Model: Kir-C3		Date: 25-May-06	No.: RB245001
Subject: ROM History for BICU for K-C3a Asia		Prepared by: Hiromoto Saitoh	
From: 1st Tech. Support Sec. Service Support Dept.			
Classification:	<input type="checkbox"/> Troubleshooting <input type="checkbox"/> Mechanical <input type="checkbox"/> Paper path <input type="checkbox"/> Product Safety	<input type="checkbox"/> Part information <input type="checkbox"/> Electrical <input type="checkbox"/> Transmit/receive <input checked="" type="checkbox"/> Other (      )	<input type="checkbox"/> Action required <input type="checkbox"/> Service manual revision <input type="checkbox"/> Retrofit information

Subject: ROM History for BICU for K-C3a		Prepared by: M. Saiki	
From: 1st Tech. Support Sec. Service Support Dept.			
Classification:	<input type="checkbox"/> Troubleshooting	<input type="checkbox"/> Part information	<input type="checkbox"/> Action required
	<input type="checkbox"/> Mechanical	<input type="checkbox"/> Electrical	<input type="checkbox"/> Service manual revision
	<input type="checkbox"/> Paper path	<input type="checkbox"/> Transmit/receive	<input type="checkbox"/> Retrofit information
	<input type="checkbox"/> Product Safety	<i

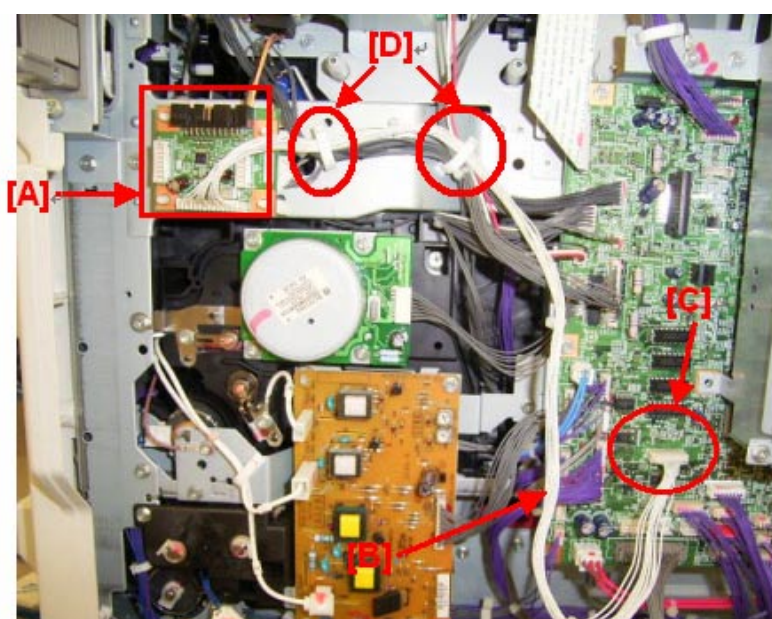
- The item in ***bold italics*** was corrected.
- Steps 5-8 were deleted.

1. Remove the rear cover.
2. Attach the bridge board [A] (***PCB STUDX4***).
3. Connect the connector [B] to CN140 [C] (13 pins) on the BICU.
4. Clamp the harness in two places [D].
- ~~5. Fix the grounding line in place with the screw [E].~~
- ~~6. Clamp the relay harness [F] in place with the clamp [G], which is included in the key counter bracket accessories (not in this interface unit).~~
- ~~7. Remove the cutout [H].~~
- ~~8. Pass the relay harness through the opening [H], and then reattach the rear cover.~~
5. ***Connect the harness for the external key counter device to CN4 (20 pins) on the bridge board [A].***
6. Reattach the rear cover.

## Point to Point diagram

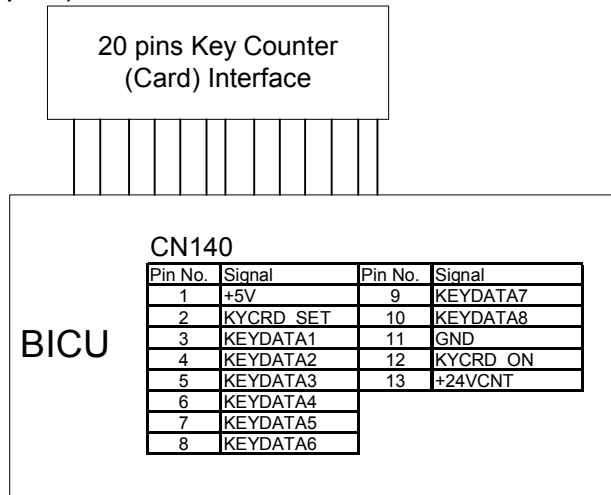
The following diagram was added for the optional Key Counter (Card) Interface Type A (20 pins).

Incorrect part number	Correct part number	Description	Q'ty	Int	Page	Index	Note
	B1212252	UPPER PCU CASE	0 - 1		37	#25

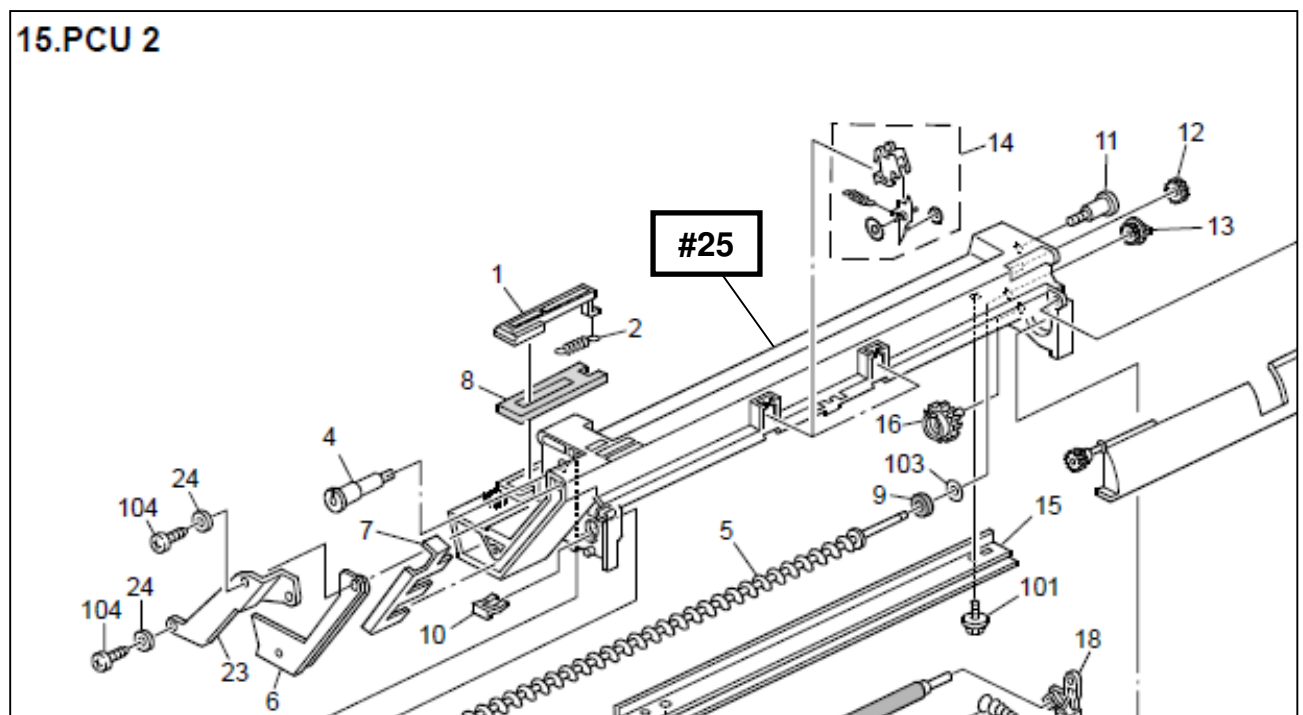
**Change:** An index in the illustration was added.

**Reason:** Correction of illustration and part number.

See the following diagram for the corrected illustration.

Incorrect part number	Correct part number	Description	Q'ty	Int	Page	Index	Note
	B2381845	SEAL:EXPOSURE GLASS	0 - 2		14	#19

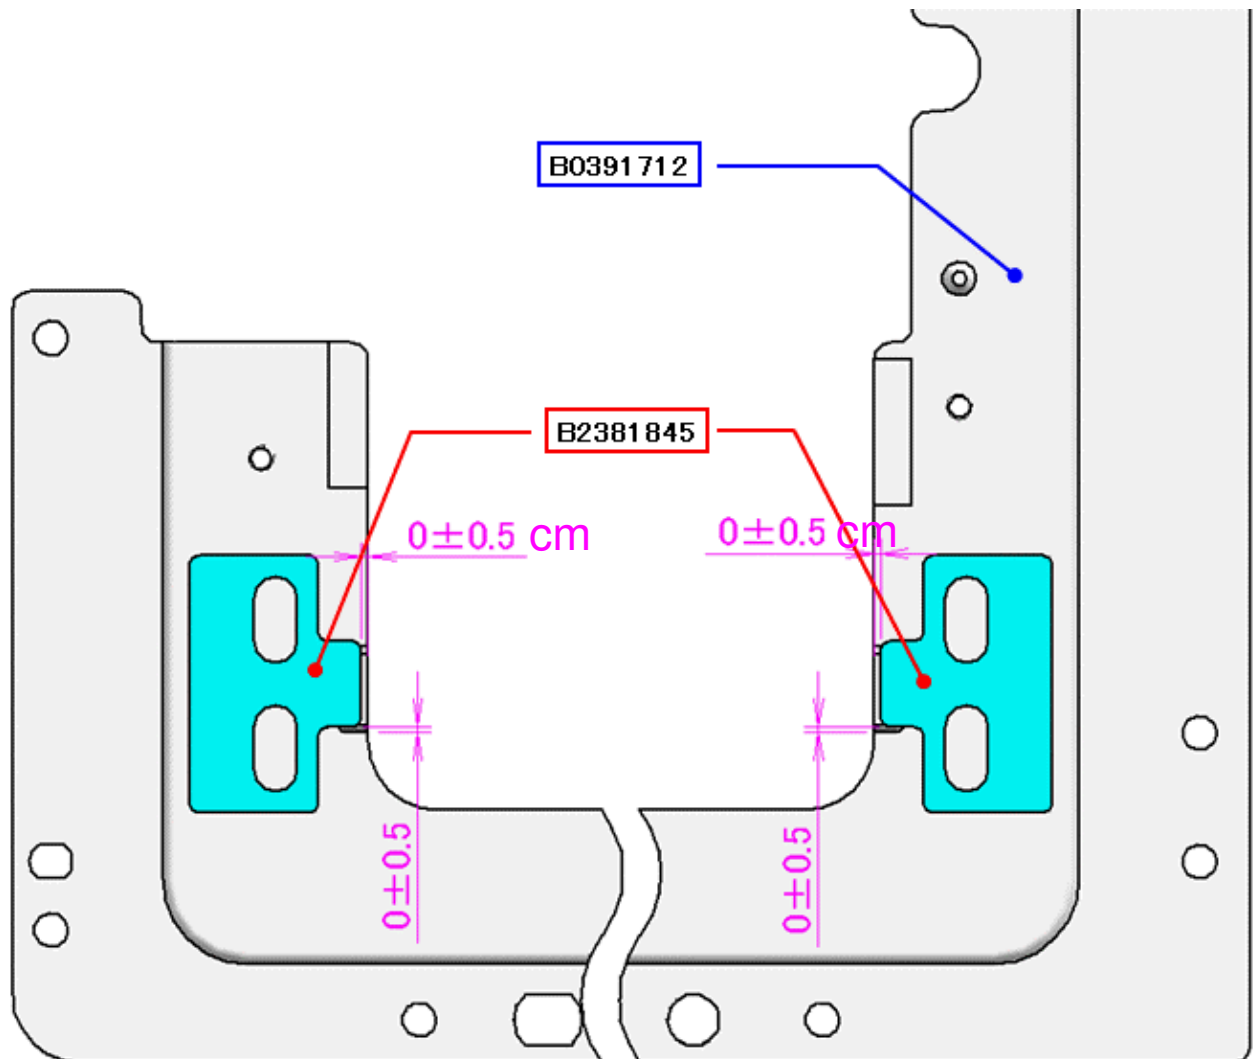
**Change:** The indexes of the illustration were changed.

See the following diagram for the corrected illustration.

Incorrect part number	Correct part number	Description	Q'ty	Int	Page	Index	Note
	B2431451	CASE:OPERATION SUB-UNIT	0 - 1		13	#20

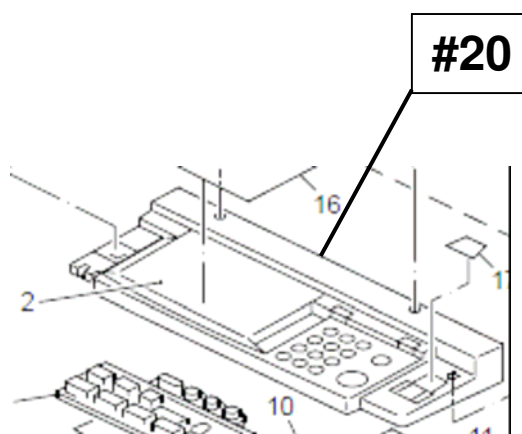
**Change:** An index in the illustration was added.

**Reason:** Correction of illustration and part number.

**See the following diagram for the corrected illustration.**

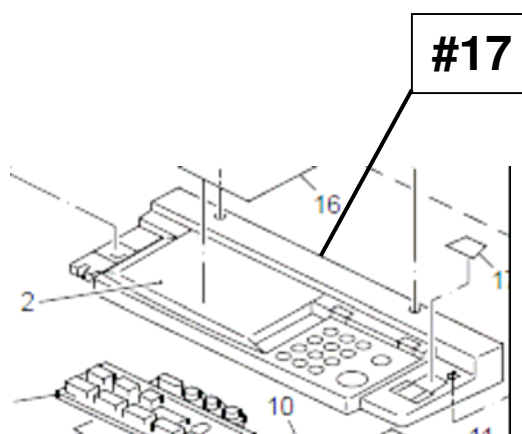
**Change:** An index in the illustration was added.

**Reason:** Correction of illustration and part number.

**See the following diagram for the corrected illustration.**

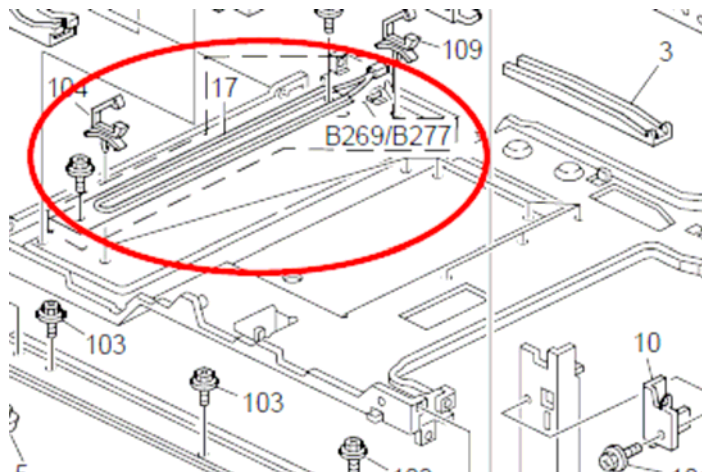
Incorrect part number	Correct part number	Description	Q'ty	Int	Page	Index	Note
B0392782		Tray Heater	1 – 0		57	17	
B0392783		Tray Heater	1 – 0		57	17

**Change:** Part Index No.17 and the illustration were deleted.

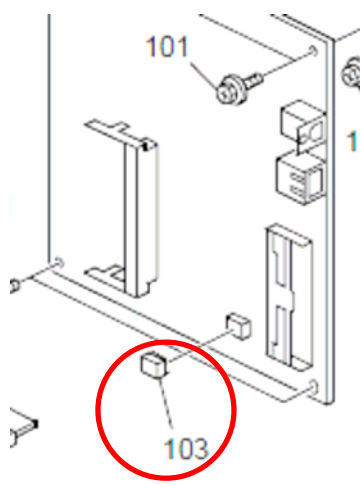
Old part number	New part number	Description	Q'ty	Page	Index	Model
14076612		EEPROM:AT24C64A-10PU-2.7	1 - 0	55	102	GW-C1
14076612		EEPROM:AT24C64A-10PU-2.7	1 - 0	57	103	GW-C2
14076612		EEPROM:AT24C64A-10PU-2.7	1 - 0	57	103	GW-C3
14076612		EEPROM:AT24C64A-10PU-2.7	1 - 0	55	102	ML316/ML316D
14076612		EEPROM:AT24C64A-10PU-2.7	1 - 0	57	103	ML319/ML319D
14076612		EEPROM:AT24C64A-10PU-2.7	1 - 0	3	103	DDST unit Type A / Type B

**Change:** Part number **14076612** and the illustrations were deleted.

**Reason:** EEP-ROM as a new spare part cannot be used on the GDI controller board as a single replacement component because it causes network connection failure. Please replace the controller board if you need to replace the RAM.

Incorrect part number	Correct part number	Description	Q'ty	Int	Page	Index	Note
	B2452840	PAPER TRAY:PD-C2:ASS'Y	0 - 1		23	*

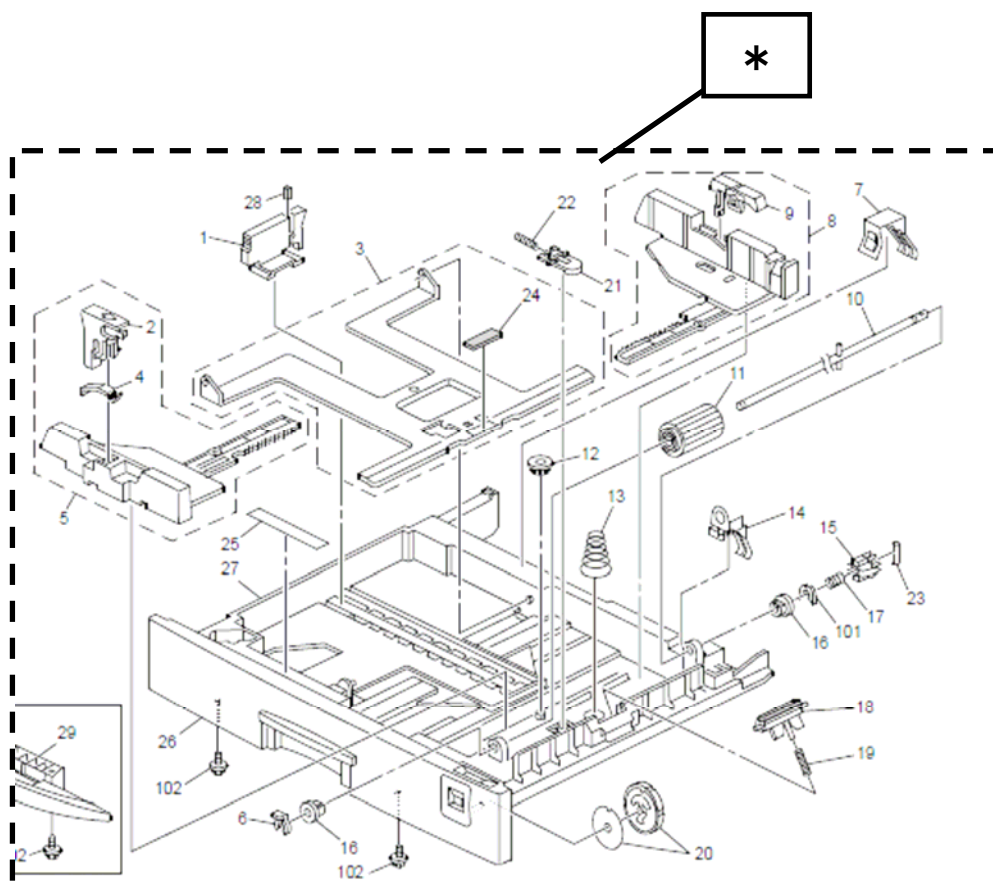
**Change:** An index in the illustration was added.

**Reason:** Correction of illustration and part number.

See the following diagram for the corrected illustration.
